# Product Change Notification

**Change Notification #: 112421 - 01**

**Change Title:** Intel® Server System E2216XXJR series  
PCN 112421-01  
Product Design  
Chassis mechanical changes  
**Reason for Revision: PCN CANCELLATION**

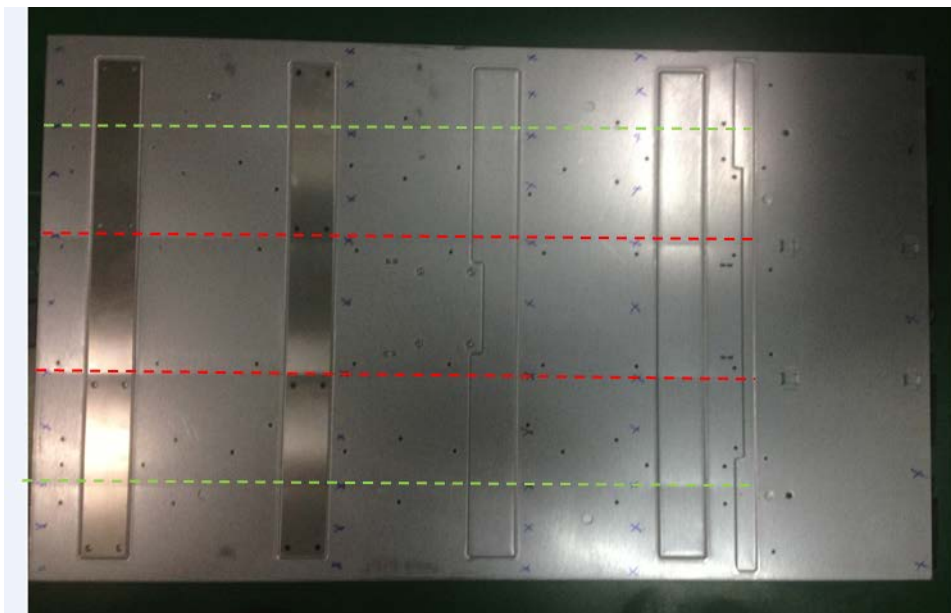
Changes have been made to strengthen the chassis bottom:

1. Extend pre-bend area to HSBP, add 2x more crimping lines (Green Lines)
2. Adjust bending angle of side wall to be  $89.5 \pm 0.5^\circ$
3. Increase pre-bend height to  $5.25 \pm 0.75\text{mm}$
